Addendum D3

re: **Centerville-Abington Community Schools**
Centerville-Abington Transportation Building
 473003.00

issue date: **March 25, 2022**

Site Utility Plan

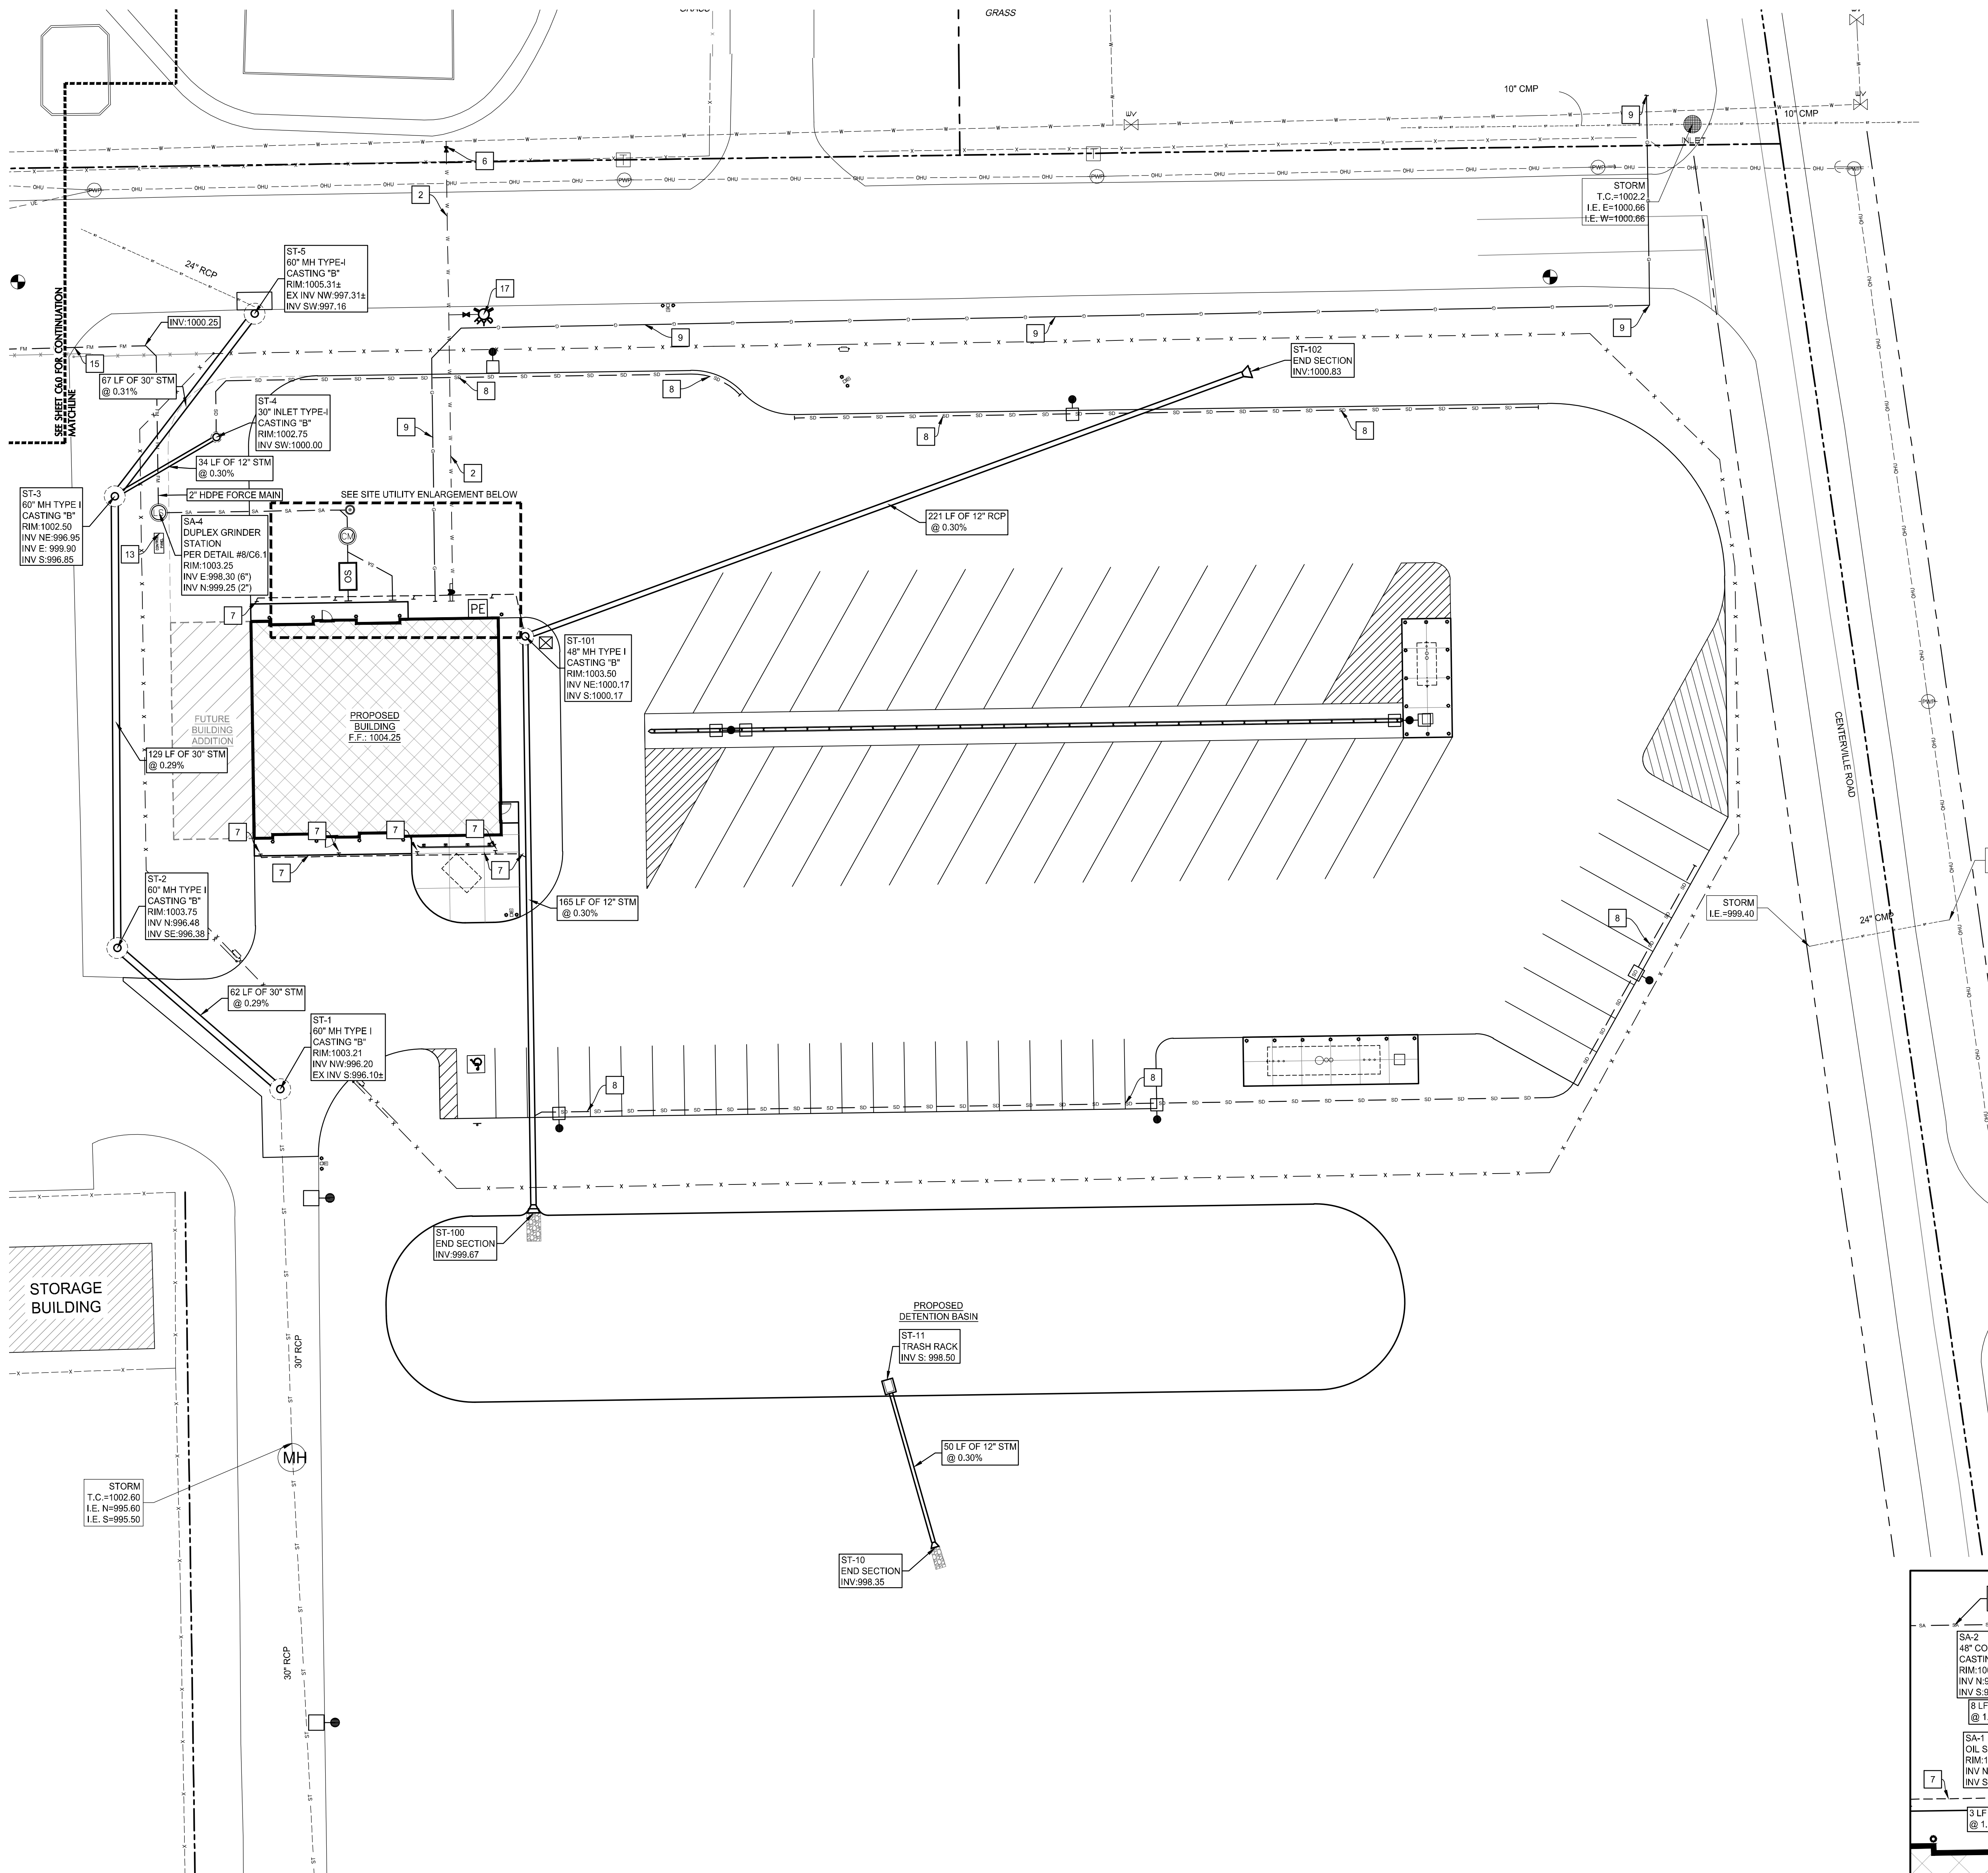
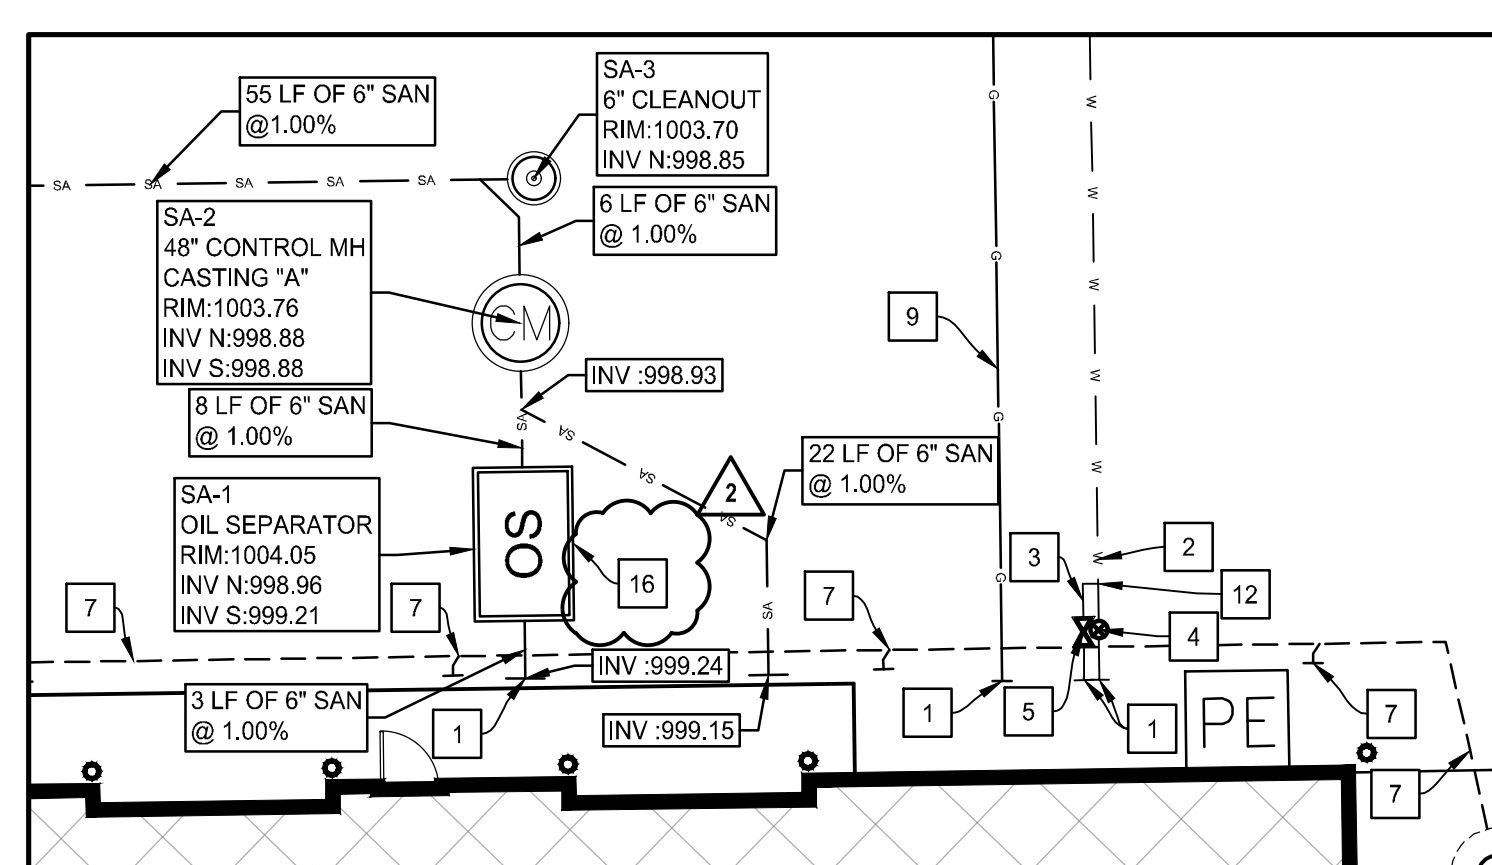
ITEM	LOCATION	DESCRIPTION
A3.01	SPECIFICATIONS Table of Contents (Reissued)	<u>CHANGE:</u> Issued as part of Addendum D3 is the REVISED Table of Contents that shall be included as an integral part of the project construction documents.
A3.02	DRAWING Sheet A4.0	<u>CHANGE:</u> CHANGE door thickness for Door 100 from 2 ¼" to 1 ¾". Drawing not reissued.
<u>CIVIL:</u>		
C3.1	DRAWING C4.0 Site Utility Plan (Drawing Reissued)	<u>ADD:</u> Added Utility Tag #16 to the plan to reference the Oil Interceptor detail. See reissued sheet C4.0.
C3.2	DRAWING C7.1 Site Detail Sheet (Drawing Reissued)	<u>ADD:</u> Added Detail #9 – Oil Interceptor detail and Detail #10 – Inlet Type I detail to the project.

- OIL INTERCEPTOR PER DETAIL #9/C7.1.
